TM146-03F01 Peer Review Acoustic Advice - 2023 (r1)

50-52 Buffalo Road, Gladesville - Peer Review of Acoustic Report for Metal Recycling Facility

The report reviewed is *Noise and Vibration Impact Assessment – 50-52 Buffalo Road, Gladesville* dated 20/1/2023 by Pulse White Noise Acoustics (Rev 0) – the PWNA Report.

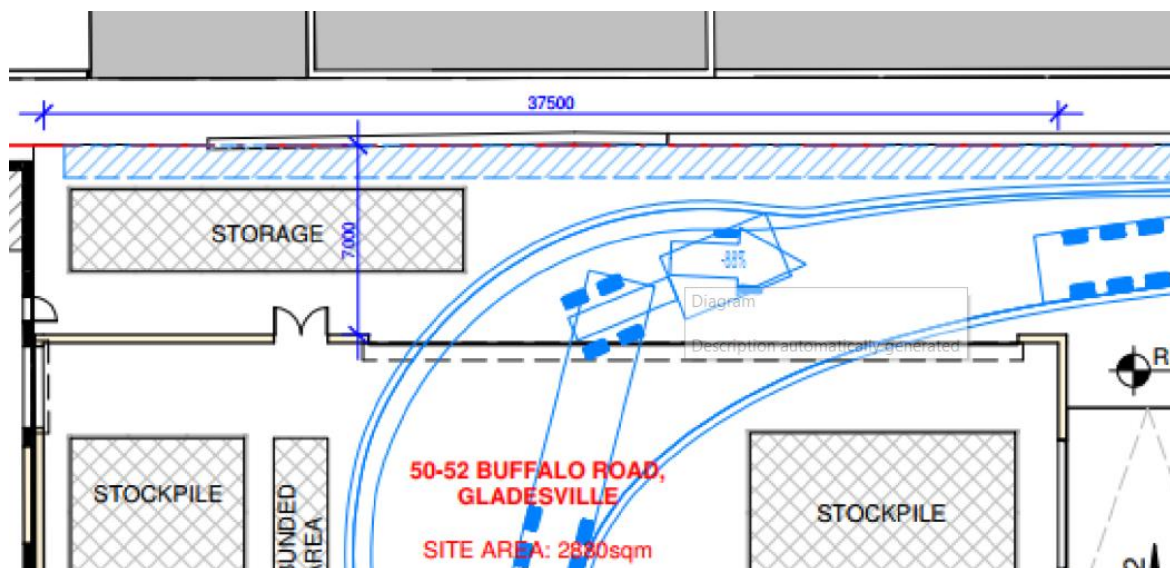
More importantly, it is not stated if the 85dB(A) is a sound *pressure* (ie – an average noise level within the internal space) or a sound *power* (the total sound energy at the door, taking into account the door size). This is very important when looking at the predicted noise emission through the open doors.

In short, if the typical noise level within the facility is 80dB(A), the sound energy at the opening (the door) will be:

In this case, the door appears to be over 20m long and I assume approx. 3-4m high. That being the case, the *sound power* at the opening would be approximately 93dB(A), not 85dB(A) as presented in table 19 of the PWNA report:

The noise level that should be used for predictions is potentially 8-13dB(A) higher than what is presented in table 19 of the PWNA report.

The PWNA Report should be revised to be clear on:

- What the sound pressure level is within the facility from the excavator, the bailer and the combined noise level.
- Confirm that the noise levels are inclusive of worst case activities (dropping/dragging car carcass) or to expressly exclude these activities from the site in management recommendations.
- What the door area has been used in calculations and the sound power at the door that has been used for noise predictions.
- Update the noise emission prediction tables, if necessary.
